# Access Compliance Report

## Public Rights-of-Way

Intersection ID: 46342	Main Street: BRANDYBUCK_LN	Cross Street: PRAIRIE_VALLEY_DR	Location: SW
ADA ID: EE3C219427A4	Ramp Type: PerpDiag	Initial Pass/Fail: Fail	Overall Compliance: No
Severity Score: 72.5			
Codes/Mitigation Info/Possible Solution		Field Measurements/Component Compliance

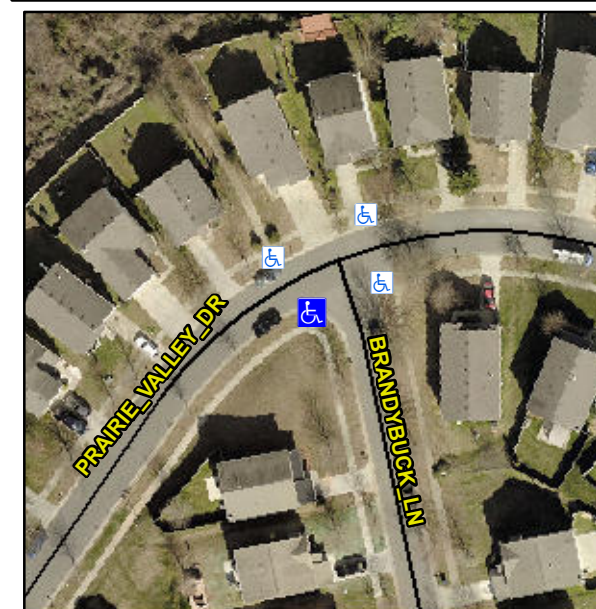
**Remove & Replace Curb Ramp With Two New Directional Ramps or Equivalent.**

**Not Found, R304.5.1, R304.2.2, R304.5.3**

Compliance	Description	Data	Compliance	Description	Data
N/A	Ramp Length (in)	84.5	No	Ramp Slope (%)	8.4
No	Ramp Width (in)	31.0	No	Ramp XSlope (%)	9.9
N/A	Flare Type LT	N/A	N/A	Flare Type RT	N/A
N/A	Flare Slope LT (%)	N/A	N/A	Flare Slope RT (%)	N/A
N/A	Flare Traversable LT?	N/A	N/A	Flare Traversable RT?	N/A
N/A	Landing Length (in)	N/A	N/A	DWS Provided?	N/A
N/A	Landing Width (in)	N/A	N/A	DWS Contrast?	N/A
N/A	Landing Slope (%)	N/A	N/A	DWS Length (in)	N/A
N/A	Landing X Slope (%)	N/A	N/A	DWS Full Width?	N/A
N/A	Landing Curb? (Y/N)	N/A	N/A	DWS Offset (in)	N/A
N/A	Shared Landing?	N/A			
N/A	Gutter Ponding?	N/A	N/A	Gutter Slope (%)	N/A
N/A	Gutter Lip Ht (in)	N/A	N/A	Gutter X Slope (%)	N/A
N/A	Painted X Walk1?	No	N/A	Painted X Walk2?	No
	X Walk 1 Direction	To E		X Walk 2 Direction	To N
N/A	X Walk 1 Width (in)	N/A	N/A	X Walk 2 Width (in)	N/A
	X Walk 1 Slope (%)	5.9		X Walk 2 Slope (%)	4.2
	X Walk 1 X Slope (%)	4.1		X Walk 2 X Slope (%)	8.6
